MEMORANDUM

REVIEW TYPE: Preliminary Plan of Subdivision

PROJECT NAME: Day Property

CASE #: 120090020

Preliminary Plan of Subdivision

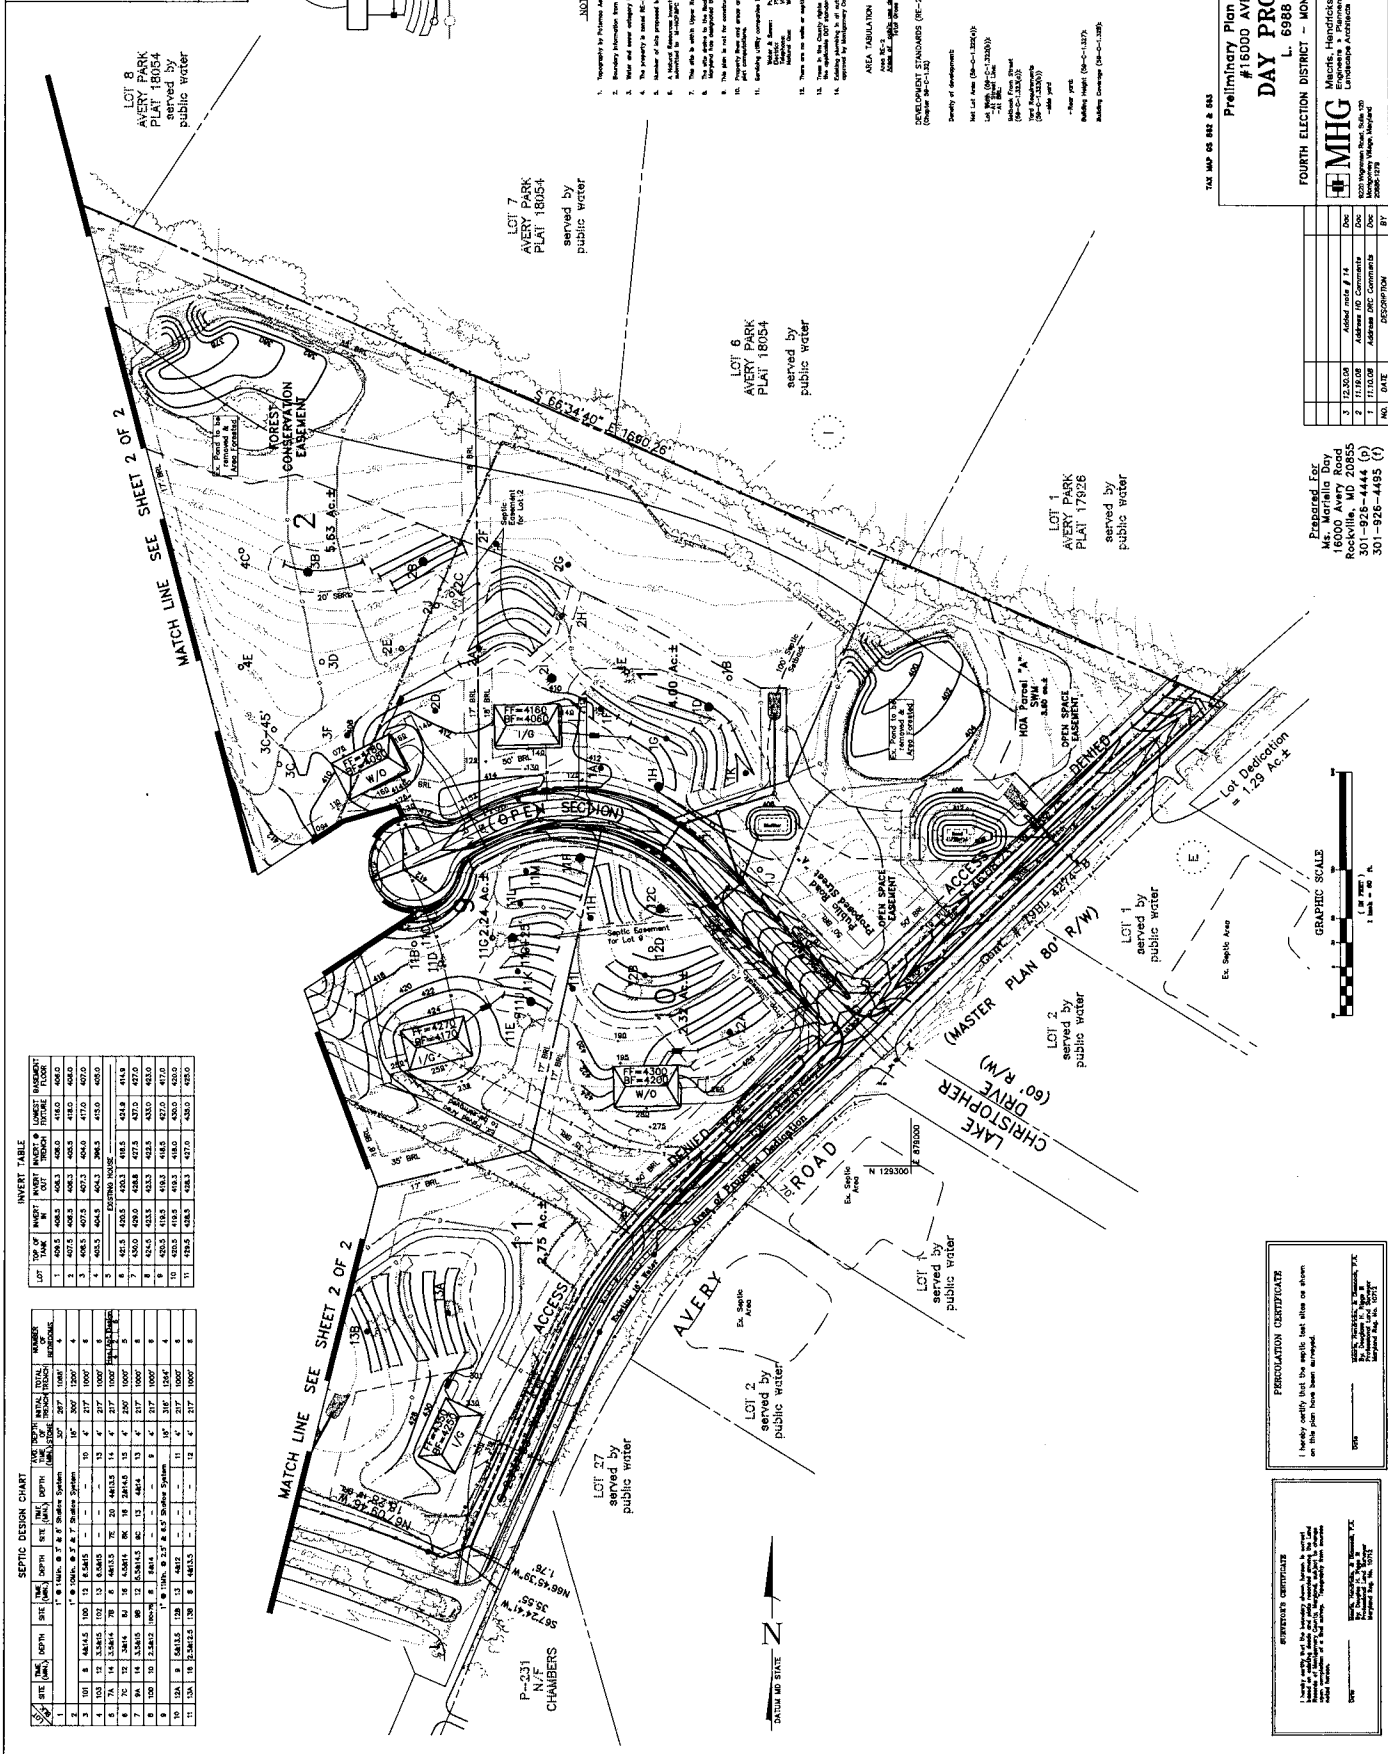
1. Show/label clearly all existing planimetric and topographic details specifically storm drainage and driveways adjacent and opposite the site as well as existing rights of way on both sides and easements on the preliminary plan.

6. Septic systems cannot be located within the right of way nor slope or drainage easements.
 7. The plan should provide horizontal alignment for the interior public street.

14. Revise the plan as necessary to meet the requirements of the Montgomery County Department of Permitting Services with regard to wells and/or septic systems.
